SP2019-022

The Lakes Assembly

SP2019-022 Site Plan for The Lakes Assembly: Please address the following comments (M= Mandatory Comments; I = Informational Comments)

**CASE NUMBER:** SP2019-022; Site Plan for House of Worship

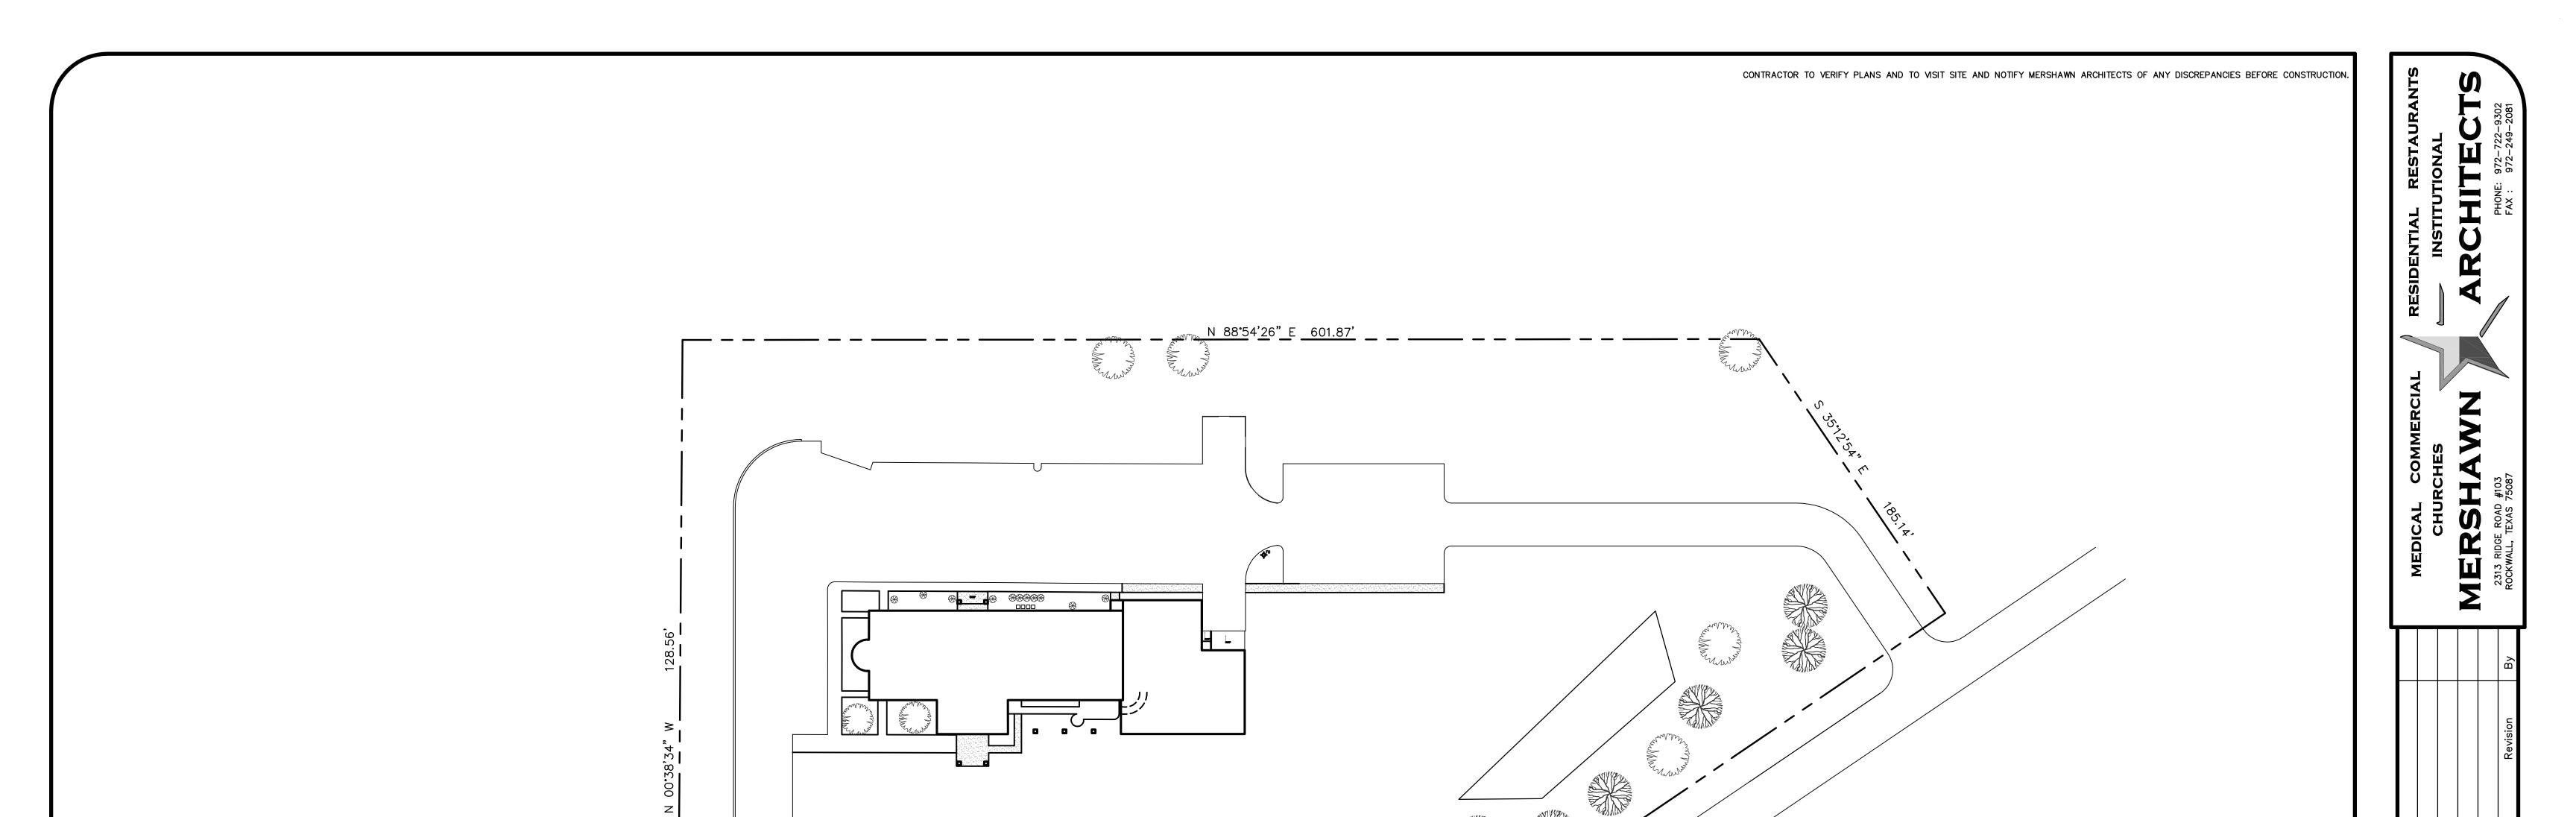
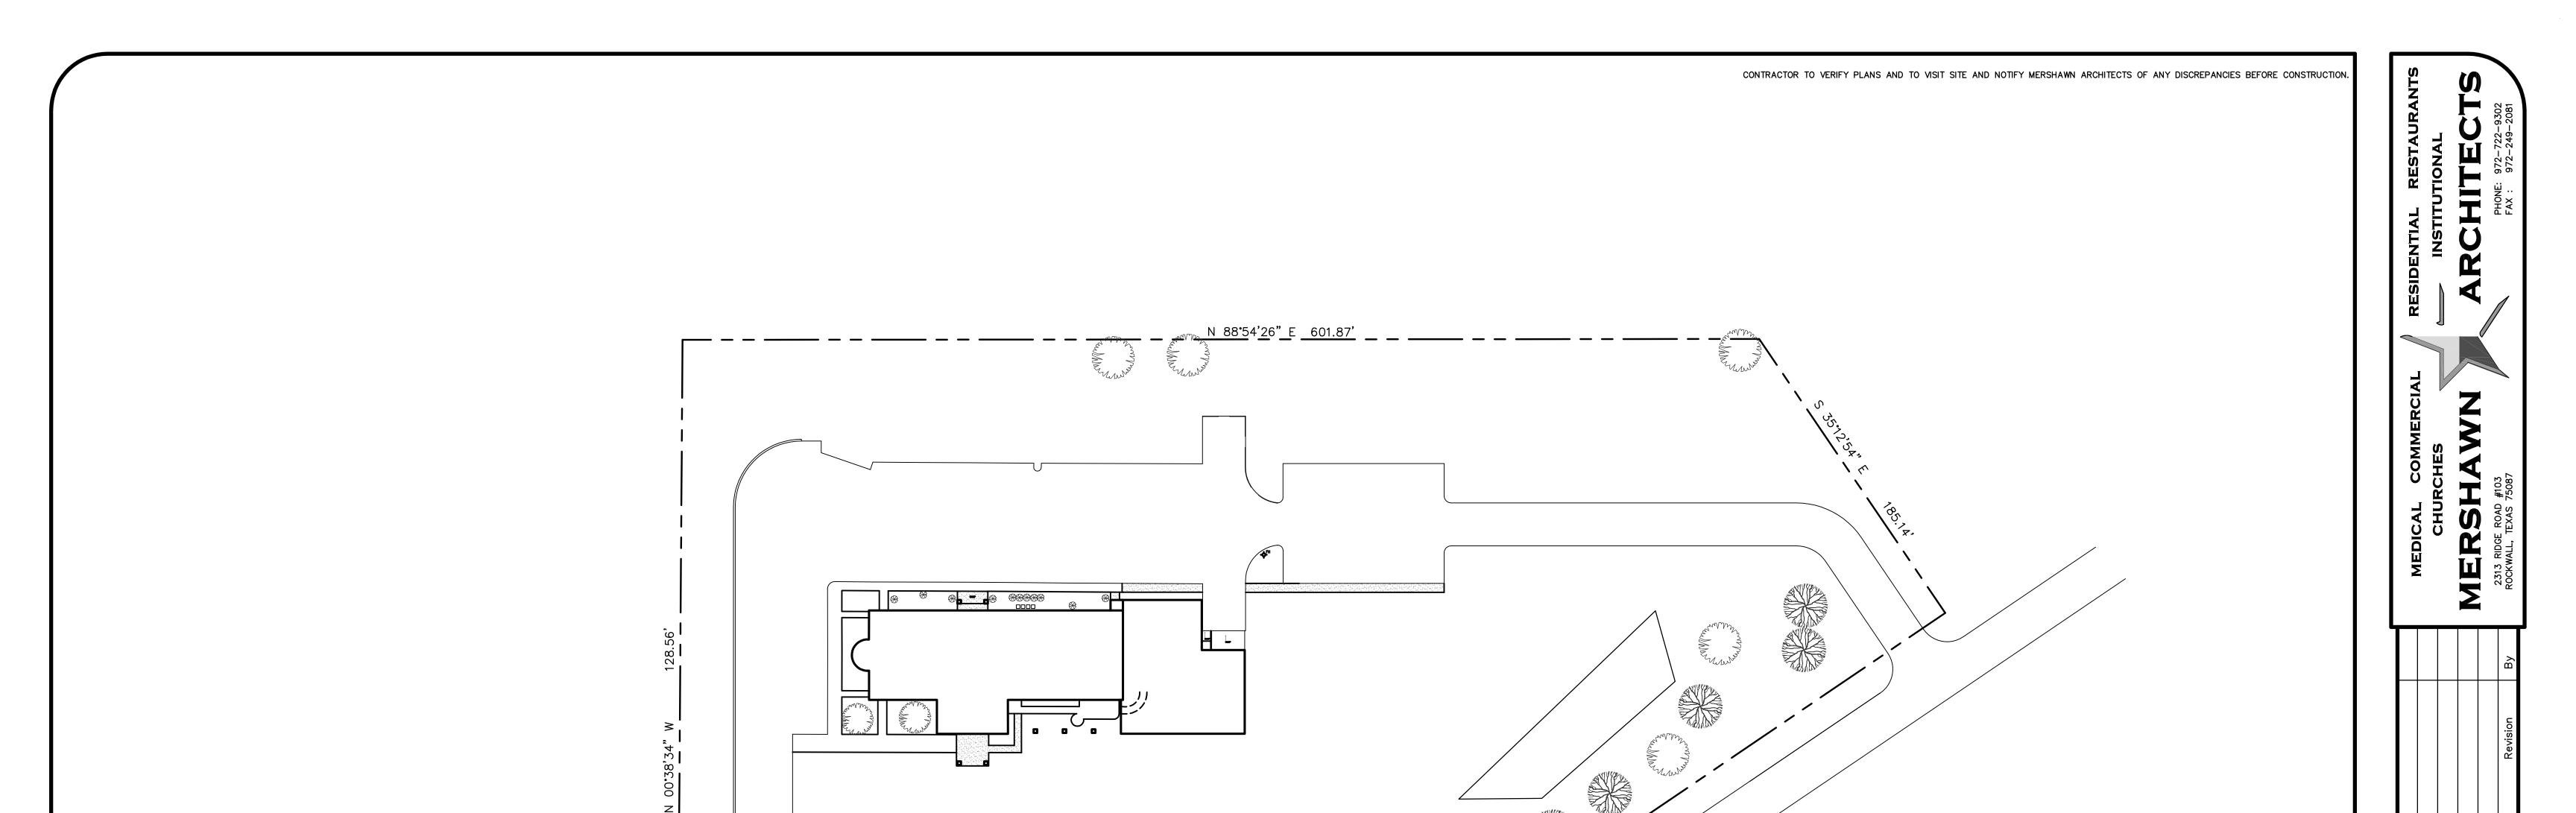
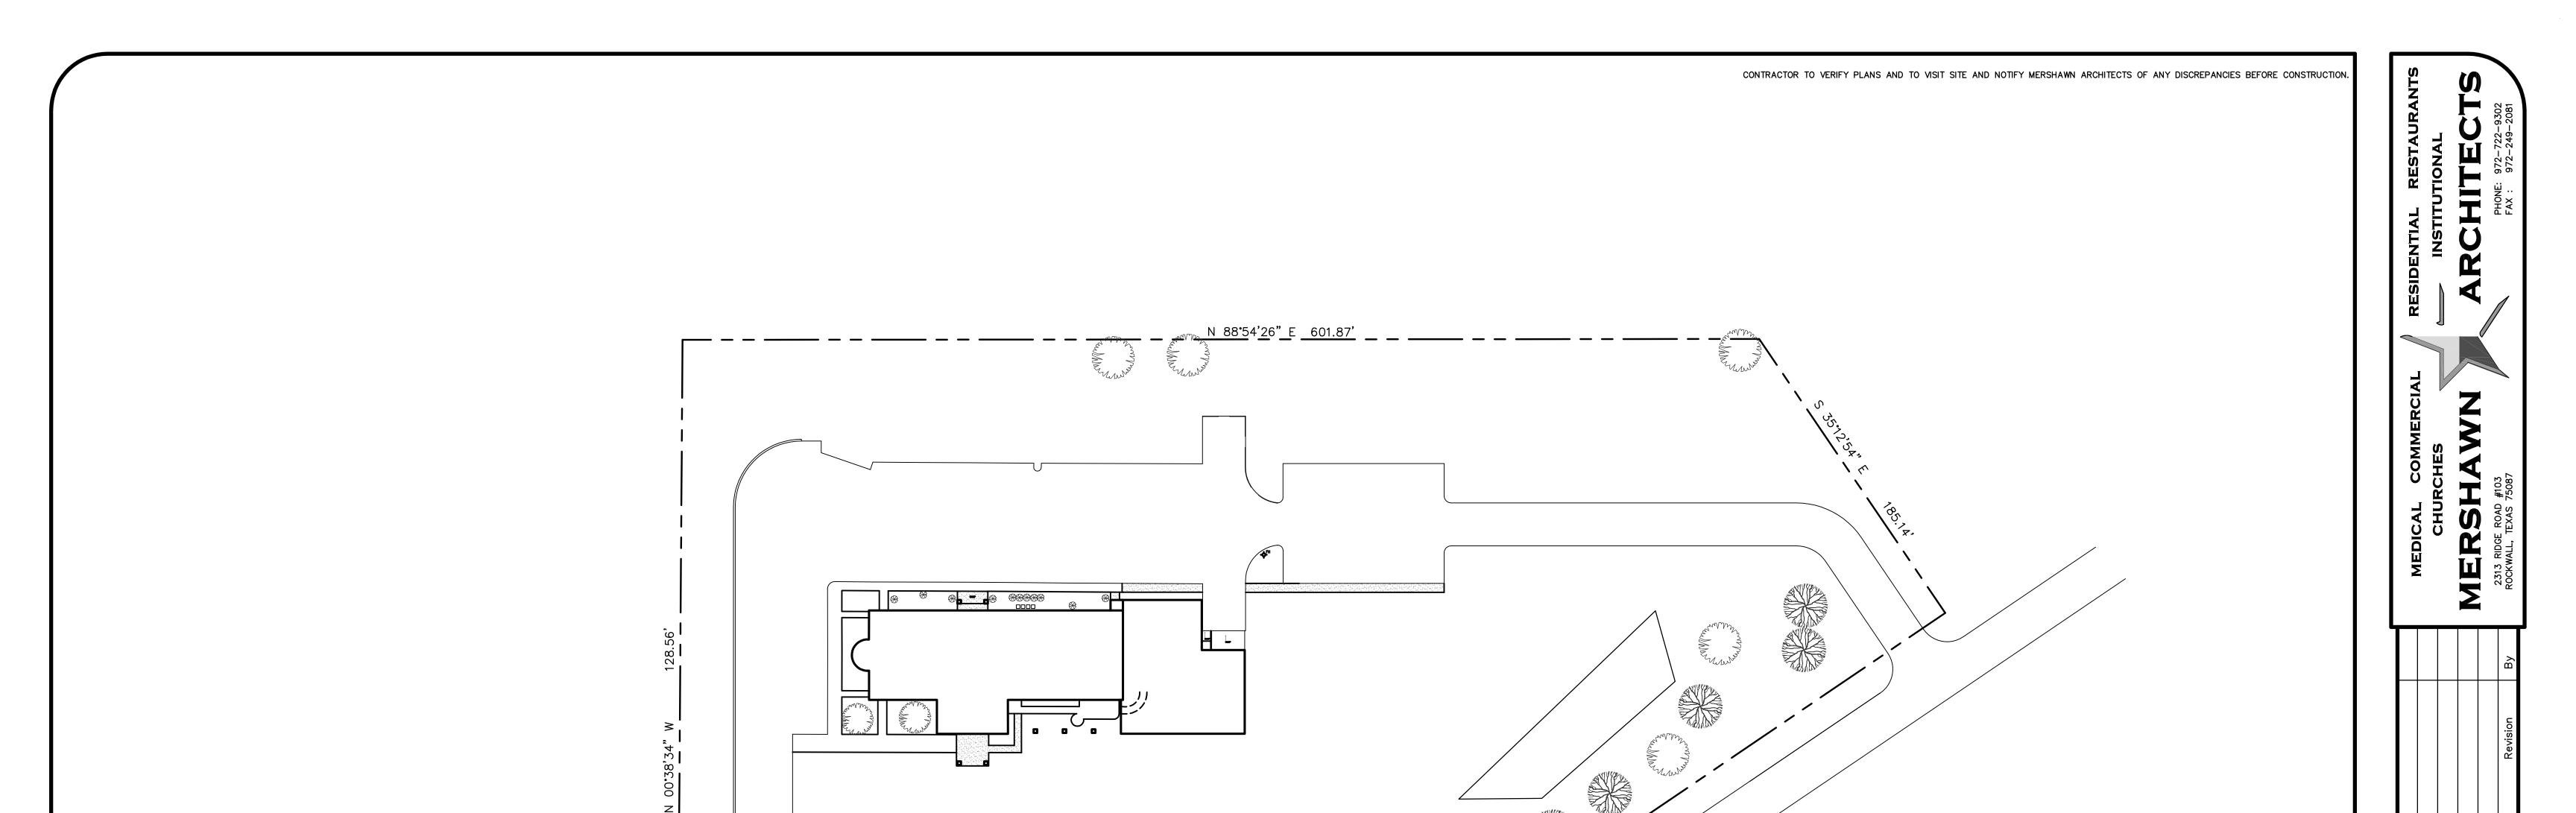
- 20. Landscape Plan—Please provide dimensions of all walls on the structure.
- 21. Landscape Plan—Please label the detention, building, firelane, parking, etc. as labeled on site plan

- 22. Landscape Plan—Please provide the same site data table and property information as shown on site plan.
- 23. Landscape Plan—Please note, hydromulch isn't typically allowed—sod may be required

- 24. Landscape Plan—Please note, there are some extra characters in the Total Landscape Area section of the plan.
- 25. Landscape Plan—Please show headlight screening from adjacent residential properties.

- 26. Landscape Plan—Are any trees being removed? Please indicate either way.
- 27. Landscape Plan--Please note that a 10-foot landscape buffer including headlight screening is required along the property lines that are adjacent to residential.

- 28. Landscape Plan—Please show vicinity map and the other labels as the site plan (e.g. label SH-66, etc.)
- 29. Building Elevations—Please provide the west elevation and indicate which elevation faces the street.
